Re: 22020378-01

Carolina Seasons Lot12-Ph2 S2-2316 Elev 'B'-Roof Truss

Pages or sheets covered by this seal: T31092866 thru T31092881

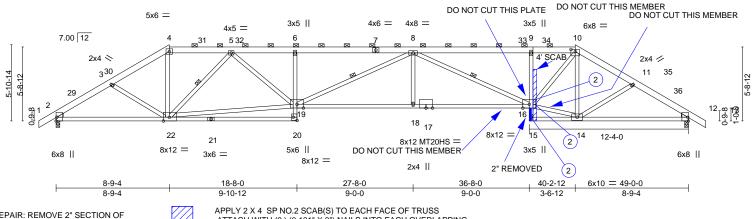
LUMBER AND CONNECTOR PLATES (SHOWN SHADED) TO BE CUT CLEANLY AND ACCURATELY AND THE REMAINING PLATE(S) MUST BE FULLY EMBEDDED AND UNDISTURBED.

REPAIR: REMOVE 2" SECTION OF TRUSS SHOWN SHADED

APPLY 2 X 4 SP NO.2 SCAB(S) TO EACH FACE OF TRUSS ATTACH WITH (2) (0.131" X 3") NAILS INTO EACH OVERLAPPING MEMBER EACH FÁCE.

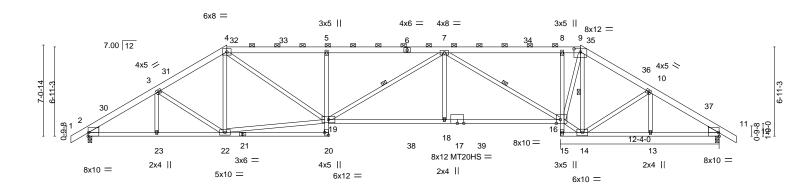
SEE DWG T31092866 FOR REPAIR DETAIL TO REMOVE 2" FROM JNT15-16

Job Truss Truss Type Qty Ply Carolina Seasons Lot12-Ph2 S2-2316 Elev 'B'-Roof Truss T31092868 Н1В PIGGYBACK BASE 22020378-01 Job Reference (optional) Lexington, NC - 27295, 8.630 s Nov 19 2022 MiTek Industries, Inc. Thu Jul 20 03:40:17 2023 Page 1 Carter Components (Lexington),

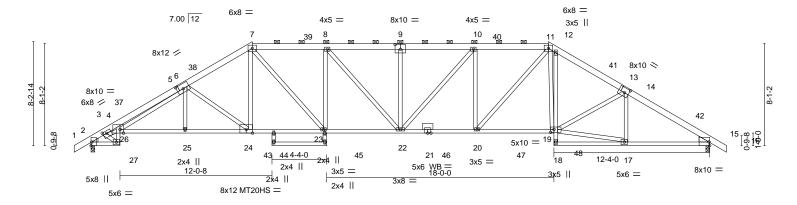
SEE DWG T31092866 FOR REPAIR DETAIL TO REMOVE 2" FROM JNT18-19

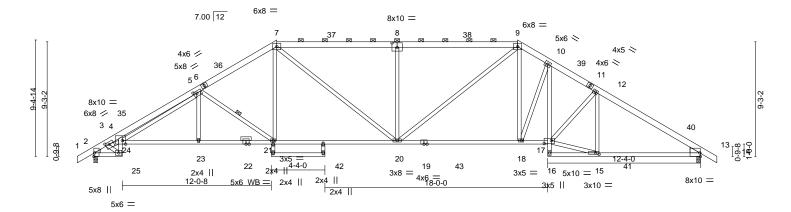
SEE DWG T31092866 FOR REPAIR DETAIL TO REMOVE 2" FROM JNT16-17

Job Truss Truss Type Qty Ply Carolina Seasons Lot12-Ph2 S2-2316 Elev 'B'-Roof Truss T31092870 22020378-01 H1 PIGGYBACK BASE Job Reference (optional)

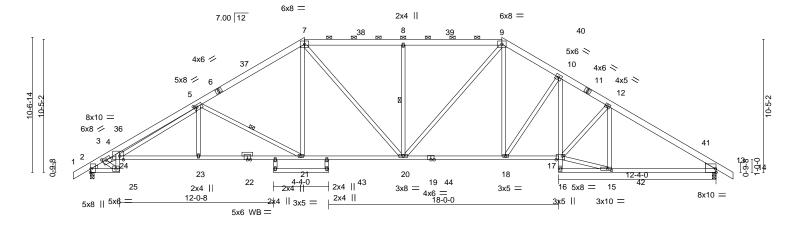
SEE DWG T31092866 FOR REPAIR DETAIL TO REMOVE 2" FROM JNT16-17 36-8-0 40-7-15

Job Truss Truss Type Qty Ply Carolina Seasons Lot12-Ph2 S2-2316 Elev 'B'-Roof Truss T31092871 22020378-01 T1D PIGGYBACK BASE 3 Job Reference (optional) Lexington, NC - 27295,

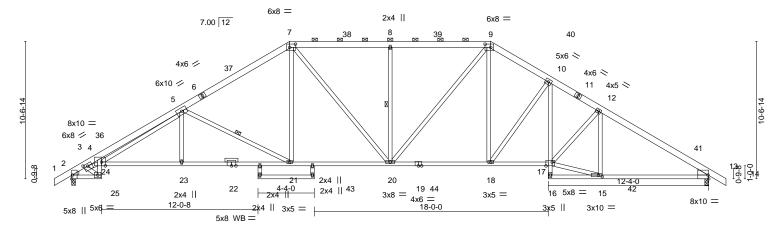
SEE DWG T31092866 FOR REPAIR DETAIL TO REMOVE 2" FROM JNT16-17

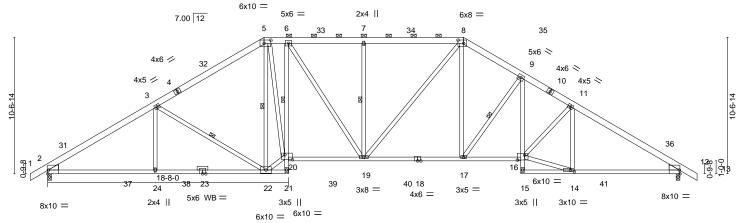
SEE DWG T31092866 FOR REPAIR DETAIL TO REMOVE 2" FROM JNT 15-16

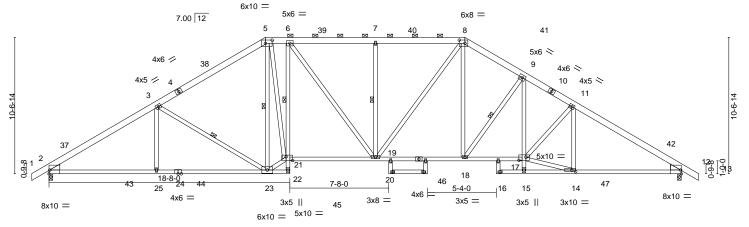
SEE DWG T31092873 FOR REPAIR DETAIL TO REMOVE 2" FROM JNT 19-20 AND JNT 21-22.

Job Truss Truss Type Qty Ply Carolina Seasons Lot12-Ph2 S2-2316 Elev 'B'-Roof Truss T31092875 22020378-01 T1B PIGGYBACK BASE Job Reference (optional) 8.630 s Nov 19 2022 MiTek Industries, Inc. Thu Jul 20 03:40:38 2023 Page 1

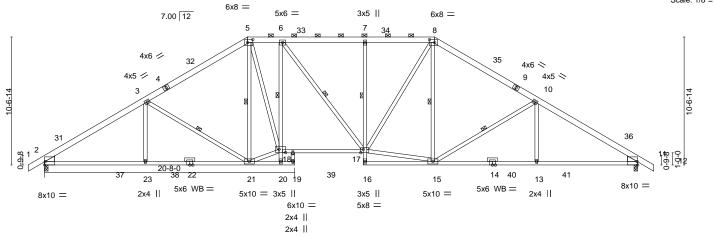
SEE DWG T31092873 FOR REPAIR DETAIL TO REMOVE 2" FROM JNT 16-17 AND JNT 18-19.

Job Truss Truss Type Qty Ply Carolina Seasons Lot12-Ph2 S2-2316 Elev 'B'-Roof Truss T31092876 22020378-01 H1S HIP Job Reference (optional)

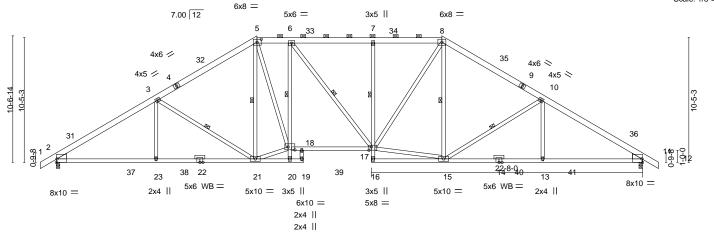
SEE DWG T31092873 FOR REPAIR DETAIL TO REMOVE 2" FROM JNT 16-17 AND JNT 18-19.

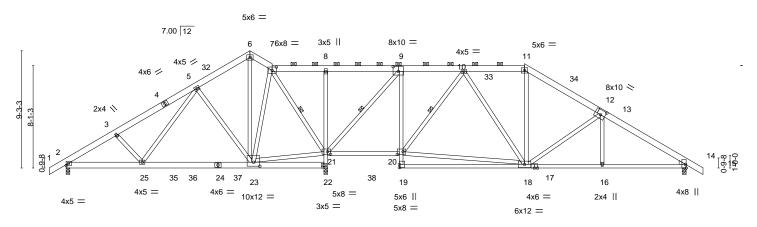
SEE DWG T31092877 FOR REPAIR DETAIL TO REMOVE 2" FROM JNT 19-20 AND JNT 21-22

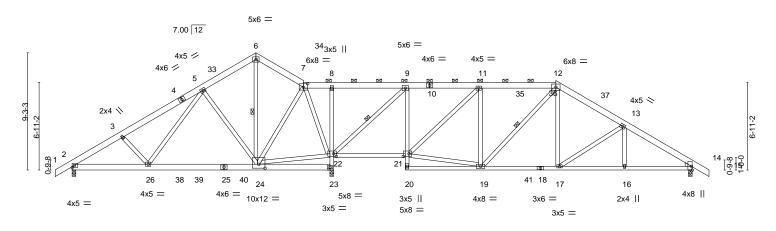
SEE DWG T31092877 FOR REPAIR DETAIL TO REMOVE 2" FROM JNT 22-23 AND JNT 20-21.
